SKB's response to NEA's second questionnaire on post-closure safety in SKB's licence application

This document presents SKB's responses to the NEA international review team's second questionnaire on post-closure safety.

The responses are provided as part of the International Peer Review undertaken by OECD/NEA as requested by the Swedish Government of SKB's reporting on post-closure safety in the licence application for a spent nuclear fuel repository.

The responses provided are to the questions specified in the OECD/NEA document **NEA/RWM/PEER(2011)3** dated 26 July 2011. NEA's brief introduction and the original questions are included in the text below. SKB's responses are given in bold after each question.

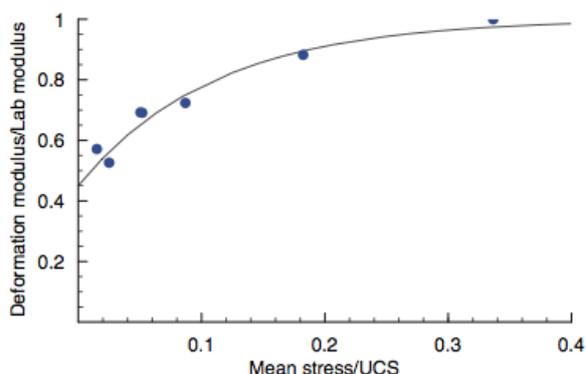
Q 2.3.9 Why are the horizontal stresses at Forsmark higher than typical for the Swedish coastline? Is there a clear relationship to the sedimentary loading and erosion history? (P. 116)

Many parts of Sweden had an erosional history similar to Forsmark and we do not think the state of stress at Forsmark can be related solely to its erosional history. However, an uncommon, but not unique, characteristic of Forsmark is the low frequency of open fractures at a relatively shallow depth. The higher the rock mass quality, i.e. the greater the stiffness, the greater the horizontal stress, in keeping with our experience with other crystalline sites. The issue is discussed in SKB R-07-26 from which the figure below stems.

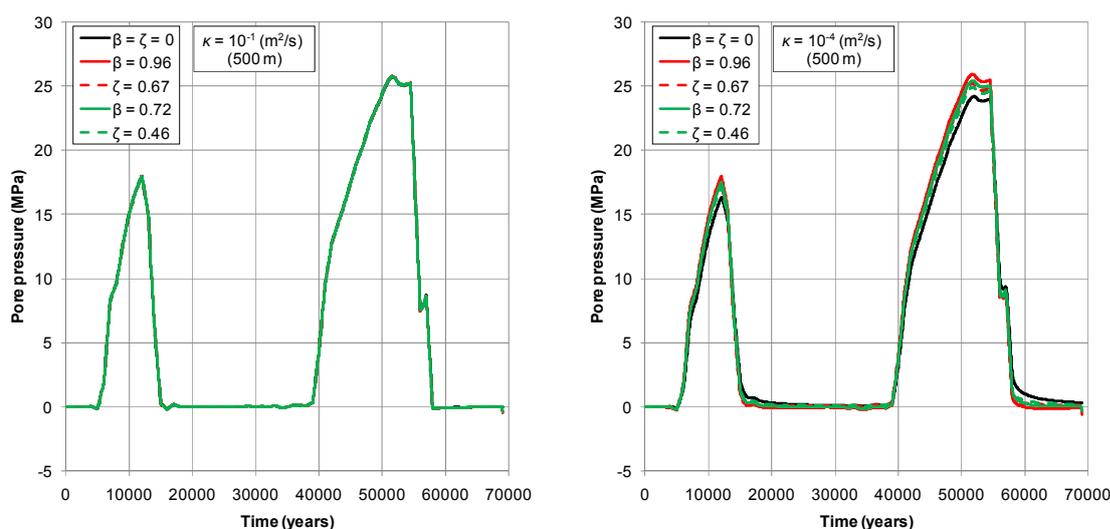
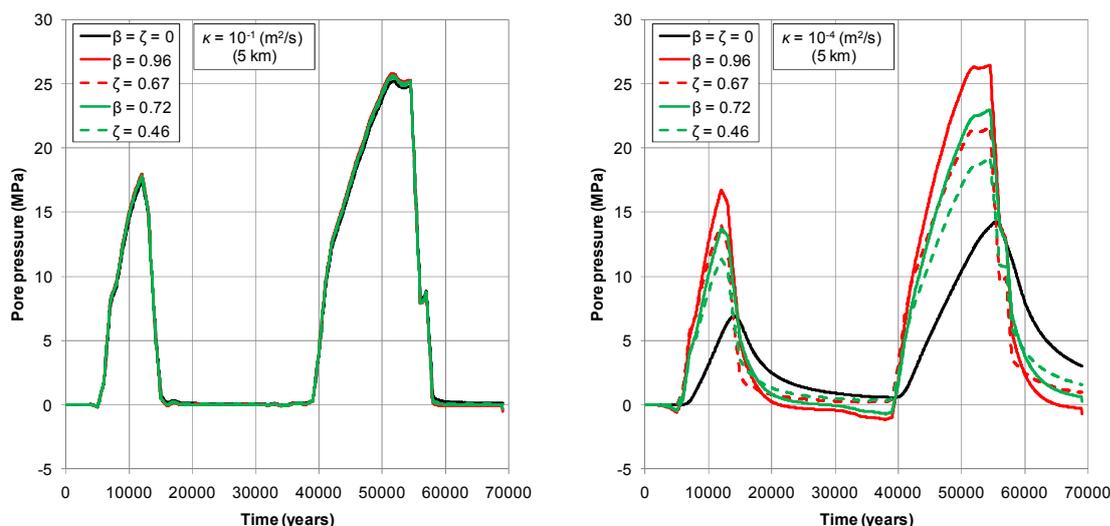
Q 2.4.7 In relation to the question 2.4.6, it is not clear whether the treatment of the pore pressure for the mechanical analysis and the groundwater flow analysis is consistent. For the mechanical analysis, a simple hydrostatic pore pressure increase by ice loading is considered; however, mechanical loading and the change of recharge amount/discharge location should affect groundwater flow, and hence, pore pressure distribution. Especially if the hydraulic conductivity of the formation is quite low, the

The hydro-mechanical coupling is ignored. The effect of ignoring that coupling is assessed in SKB R-09-35 (Appendix A, pp. 80-84) using 1D analytical solutions assuming the ice sheet to be warm-based at all times (i.e. in keeping with the maximum hydrostatic pore pressure approach explained above).

For high values of the hydraulic diffusivity, the mechanical coupling effect can be ignored (Figure 1, left column). For low values of the hydraulic diffusivity mechanical coupling does have an effect on the pore pressure at large depths, but practically none at repository depth (Figure 1, right column). Considering that the potential for mechanical instability of fractures is greatest following a de-glaciation and that results from the coupled 1D-analyses show that the pore pressure is reduced more quickly during a de-glaciation than in the uncoupled analyses, it is concluded that it is effectively conservative and therefore justified to ignore the coupling (even if the stability is overestimated at large depths during high stability periods). It should also be noted that the impact of the glacially-induced excess pore pressure on the stability decreases with depth.
